Project Title:
SEATTLE NATIONAL GUARD ARMORY

Sheet Contents: FLOOR PLAN, REFLECTED CEILING PLAN, SECTIONS, DETAILS

Sheet Contents:
KITCHEN POWER & LIGHTING PLANS

GENERAL NOTE:
SHEETS RK. 1 & RK. 2 FORM PART OF CHANGE ORDER NO. 1 - REVISION TO THE KITCHEN EQUIPMENT DINGS. DATED 5/11/73.

Architects
Structural
Mech-Elec
Landscape

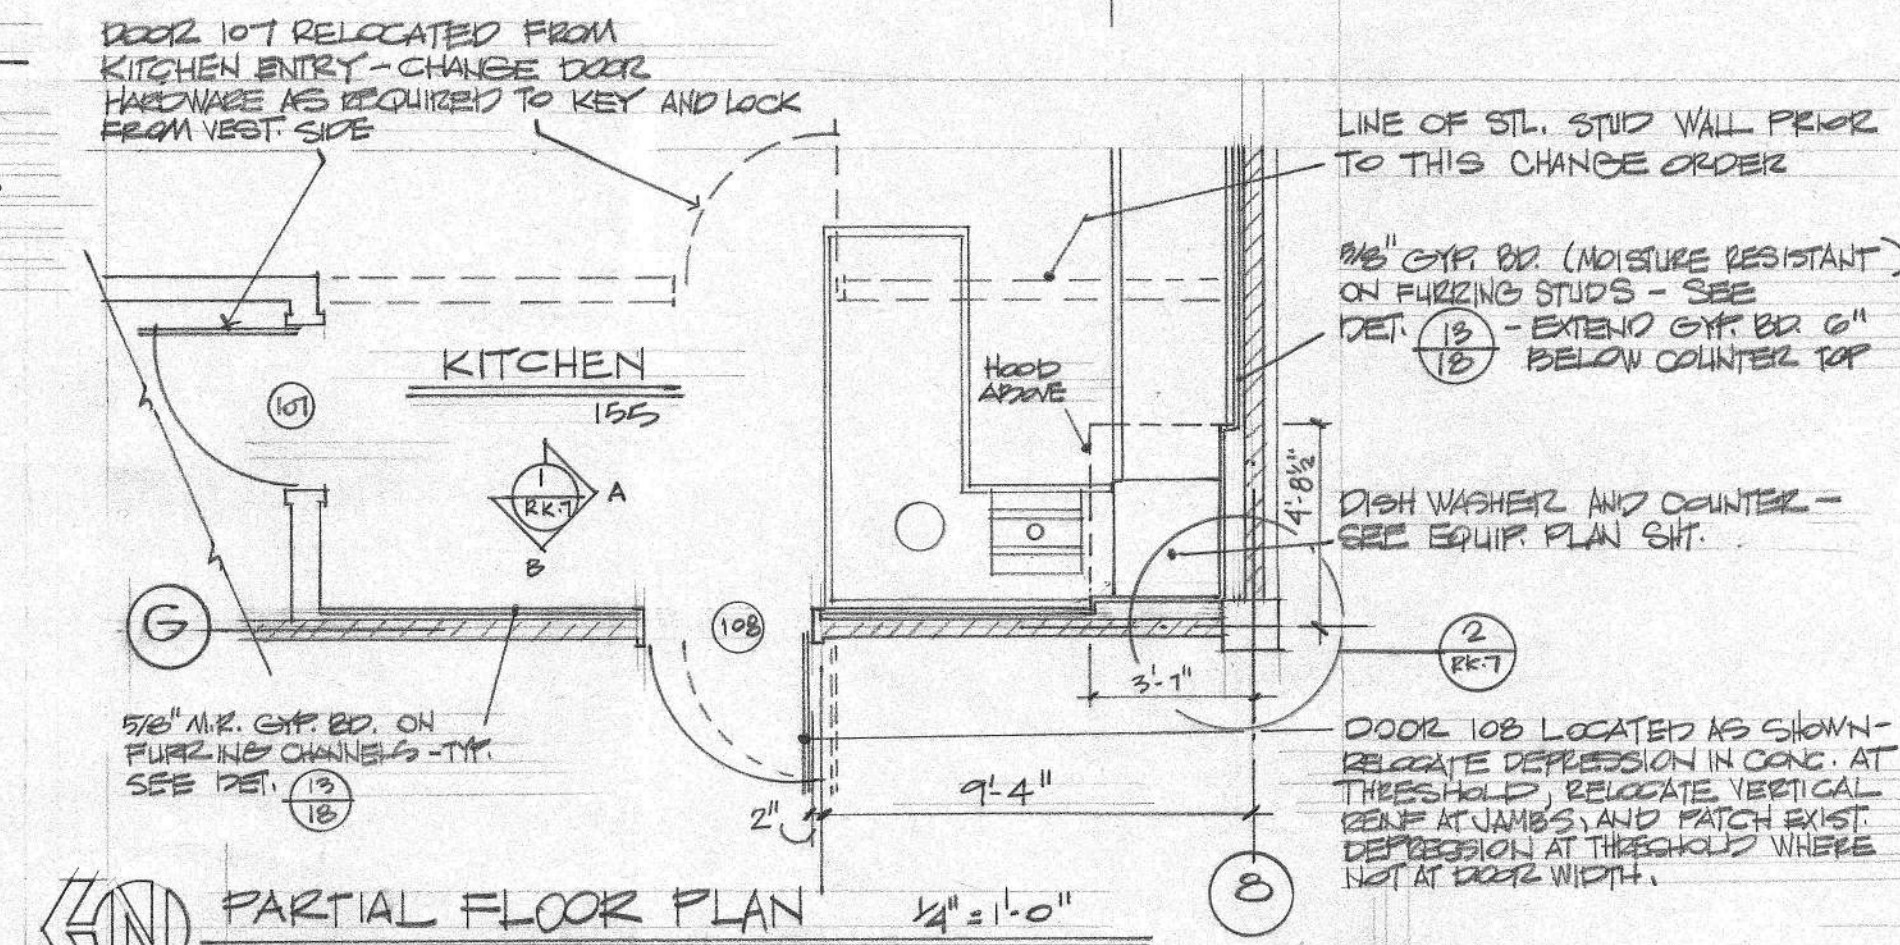
- NOTES:
1. REVISE KITCHEN EQUIPMENT POWER & LIGHTING LAYOUT AS SHOWN.
 2. RE-LOCATE PANEL "IKK" AS SHOWN & PROVIDE CKT. BREAKERS AS FOLLOWS:
(20) 20A-1P KITCHEN EQUIP. REC. & SPARE 120V.
(1) 30A-1P K1 FREEZER 120V
(1) 40A-1P K30 WALK-IN REFER. 120V
(1) 40A-2P K6 HOT FOOD CTR. 208V-1 Ø
(2) 30A-2P RECEPTACLES 120/208V-1 Ø, 3P -4W
(1) 20A-2P K2 DISPOSER 3HP 208V-3 Ø
(1) 30A-3P K32 BOOSTER 208V-3 Ø
(6) 1P SPACES
(1) 2P SPACE
(NO CHANGE TO PANEL FEEDER SIZE)
 3. ELECTRICAL CONTRACTOR SHALL MAKE ALL FINAL CONNECTIONS TO KITCHEN EQUIPMENT & PROVIDE ALL REQUIRED DISCONNECTS.
 4. REFER TO KITCHEN ROUGH-IN PLAN FOR EXACT LOCATION OF ALL OUTLETS.
 5. REFER TO CONTRACT DOCUMENTS & SPECIFICATIONS FOR ADDITIONAL INFORMATION & REQUIREMENTS.
 6. FROM PANEL "IKK" STUB (4) 1" C.O. INTO FURRED CEILING SPACE & CAP.

Sheet Contents: **REVISED ARCHITECTURAL AND KITCHEN EQUIP. PARTIAL PLANS AND DETAILS**

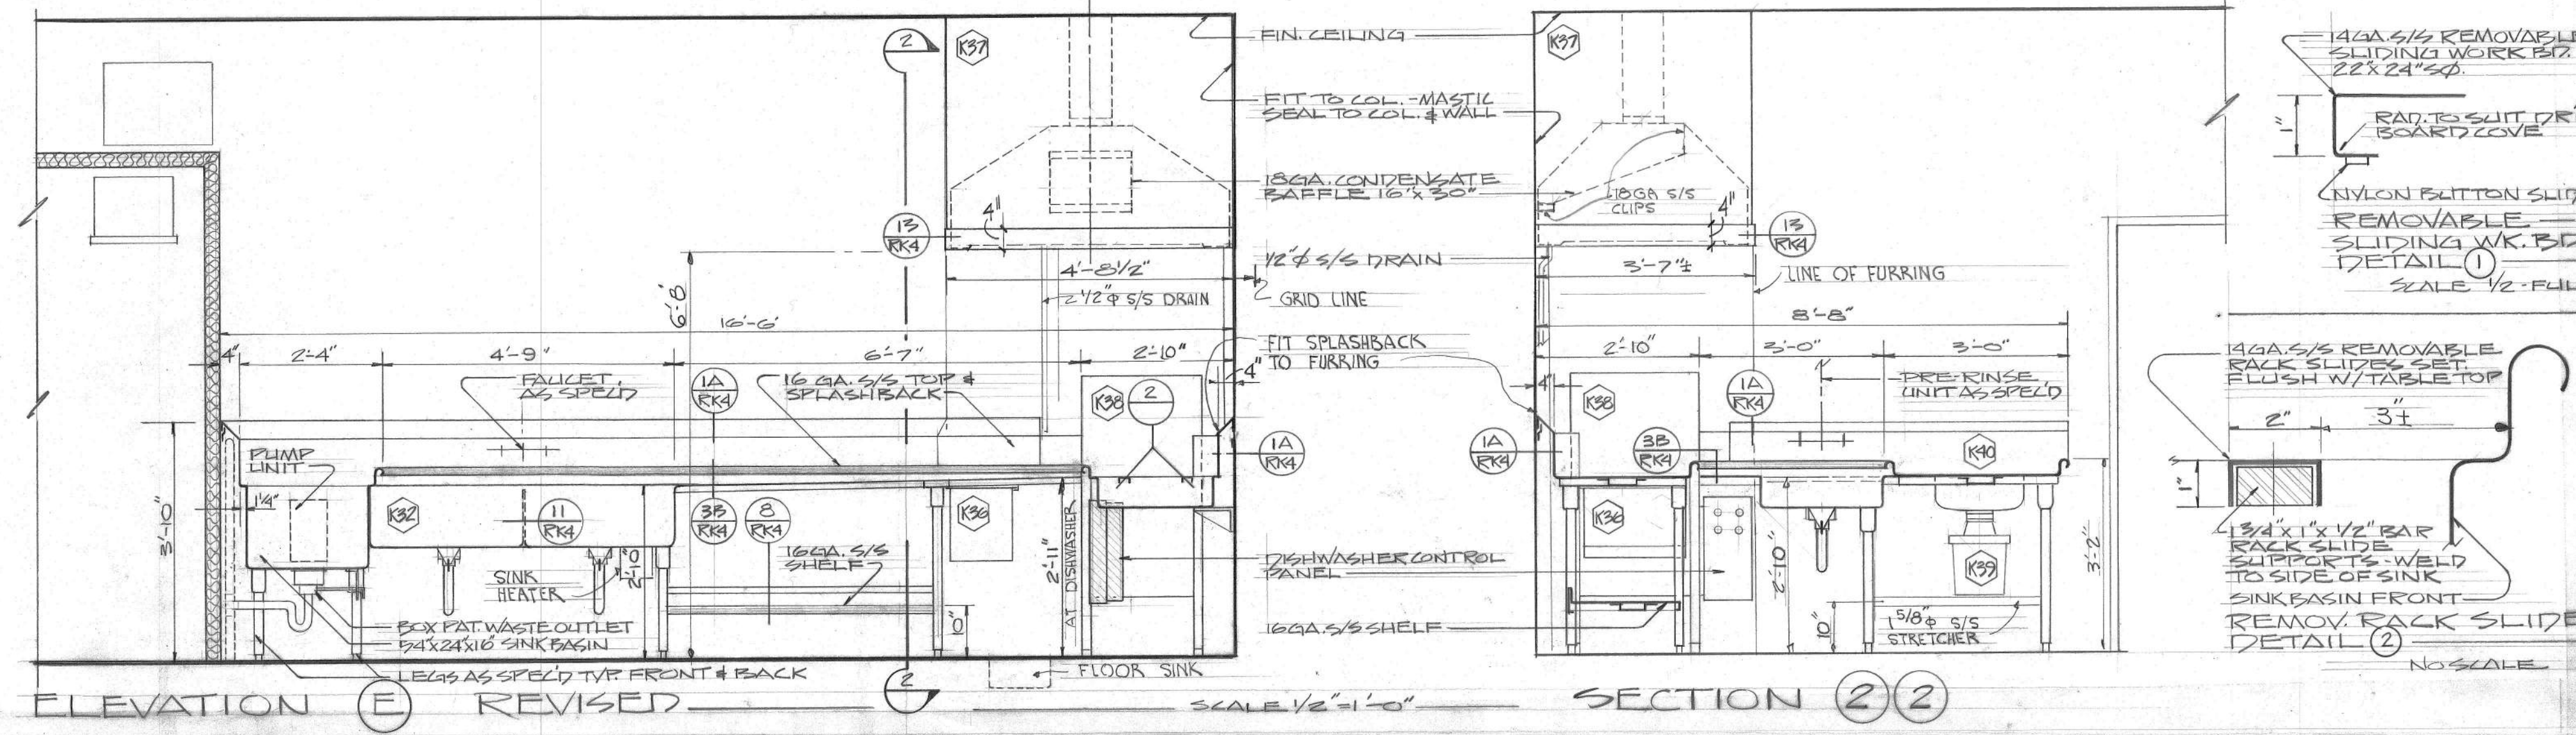
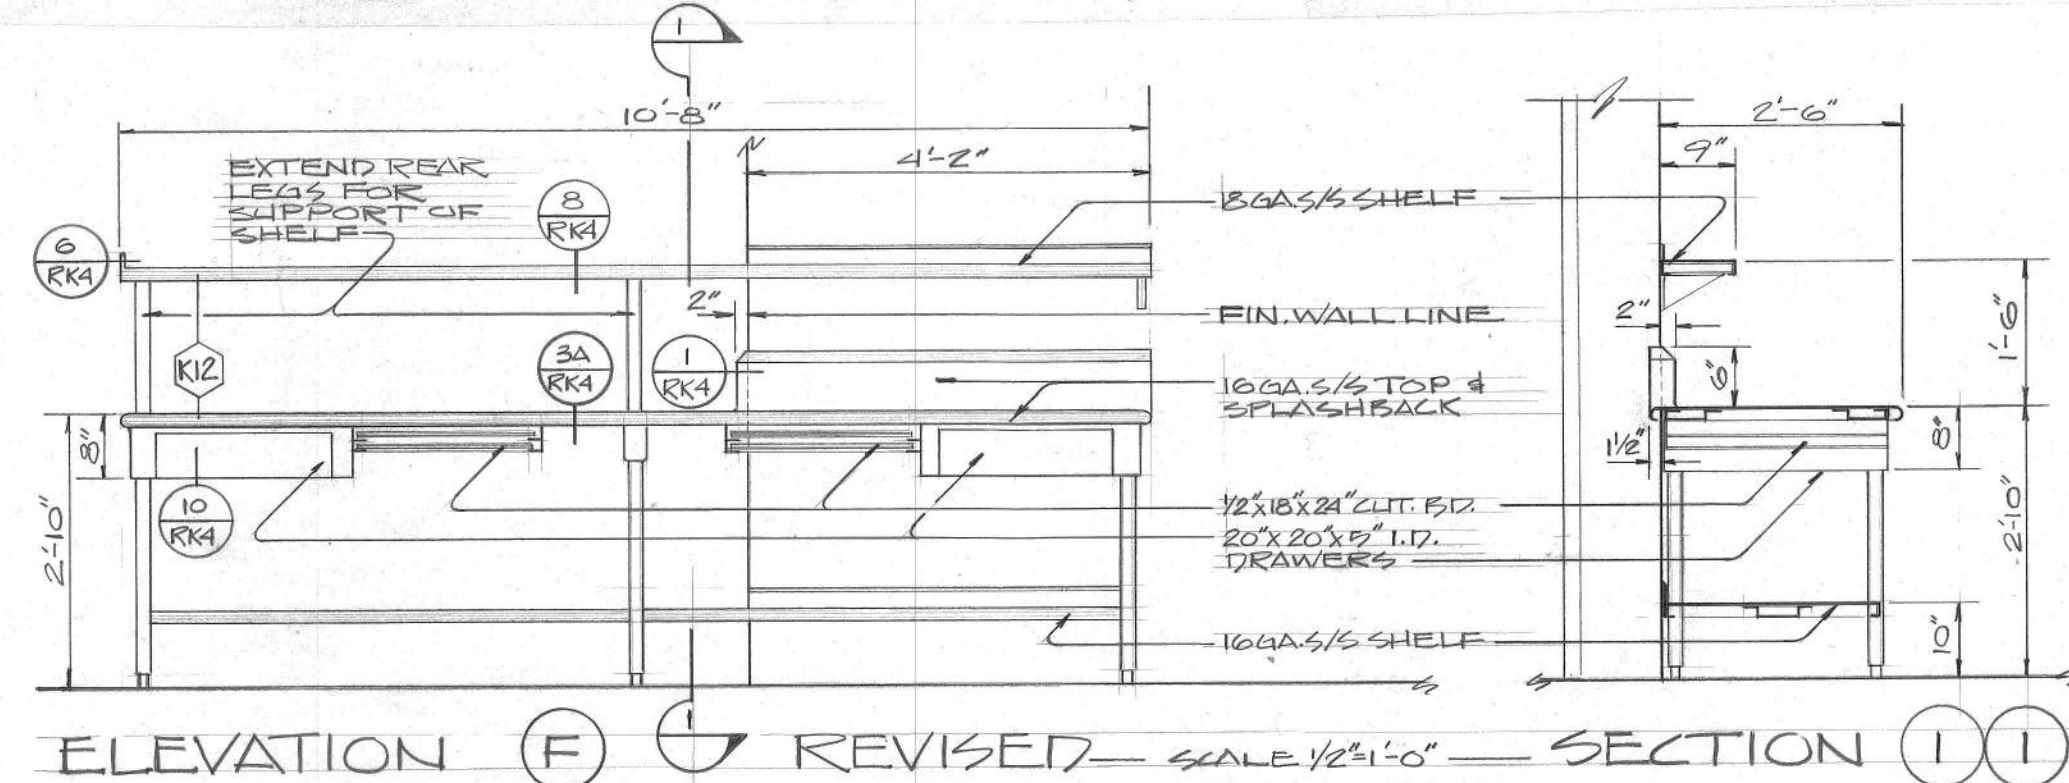
MARK NO.	EQUIPMENT ITEM	REMARKS
K32	THREE COMPARTMENT SINK	REVISE AS SHOWN
K36	BOOSTER HEATER	CONN TO K38
K37	EXHAUST HOOD	600 CFM
K38	DISHWASHER	
K39	DISPOSER	
K40	SOILED DISH TABLE
